Commonwealth Edison

August 23, 1985

Subject: Byron Station Unit 1
Environmental Effects of High
Energy Line Breaks
NRC Docket No. 50-454

FIGURE 1C
STEAM GENERATOR BLOWDOWN SYSTEM HELB MONITORING
(UNIT 1)

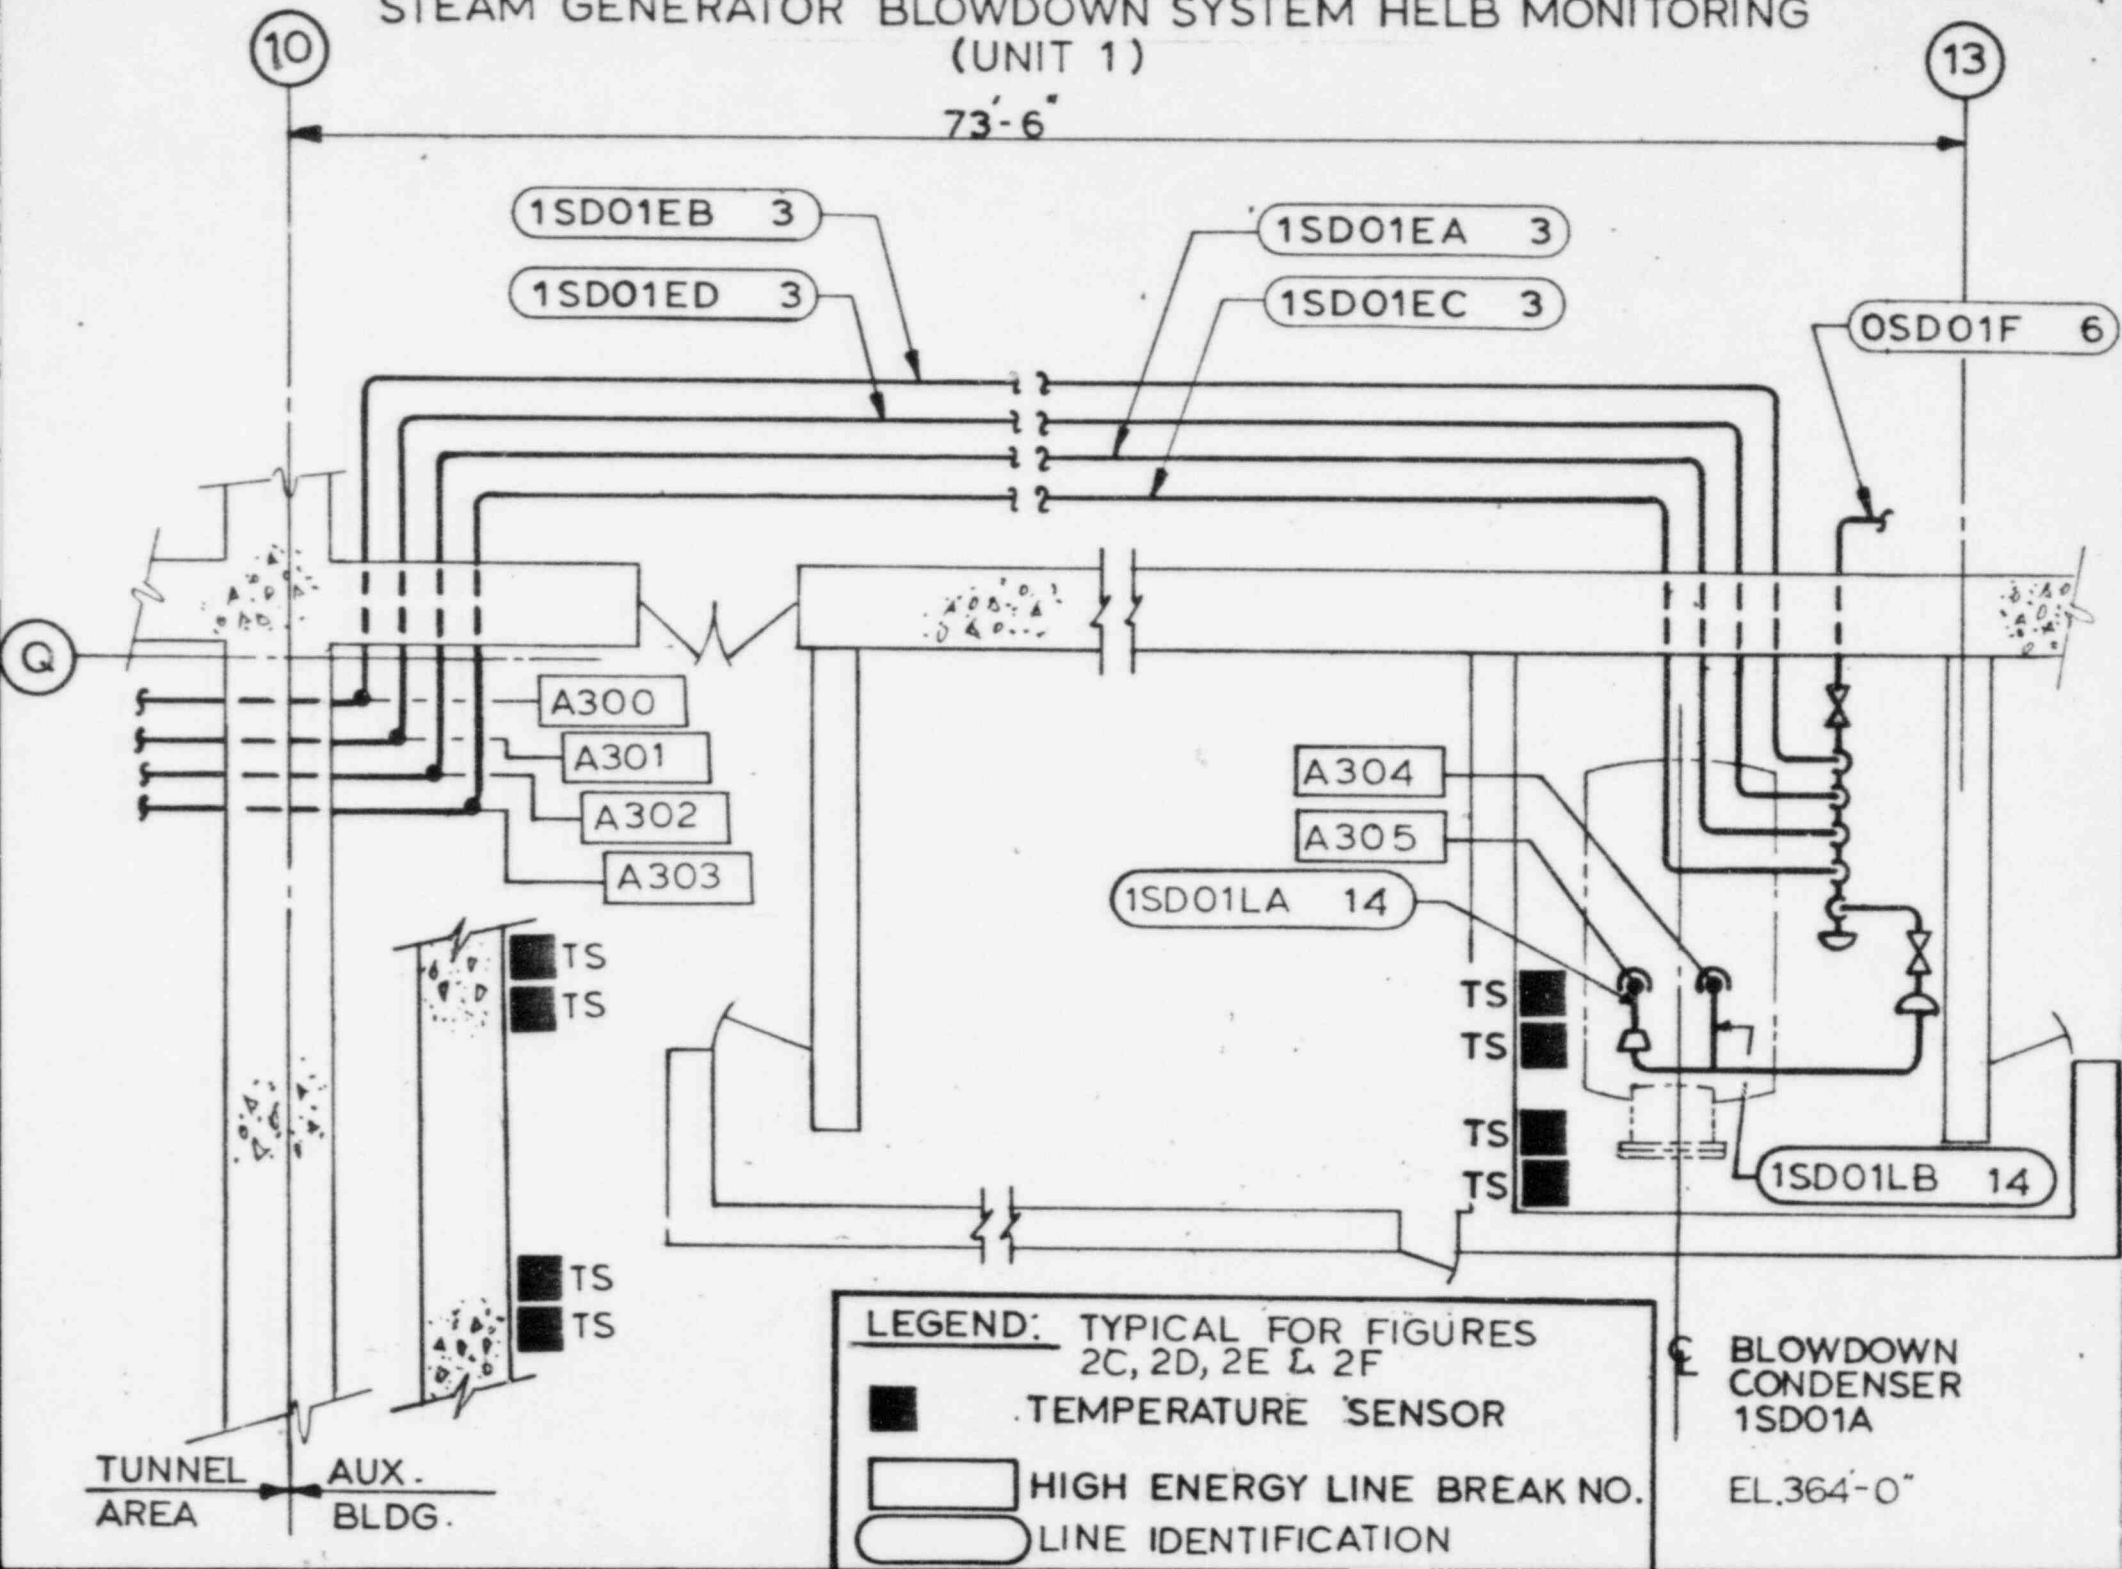
Equipment interference problems have prevented the installation of some of the temperature sensors in locations as originally described in reference (a). The revised locations of these sensors are shown on the attached figures. The relocation of these sensors does not reduce their effectiveness to promptly detect the adverse environmental conditions associated with high energy line breaks in the SD and AS systems.
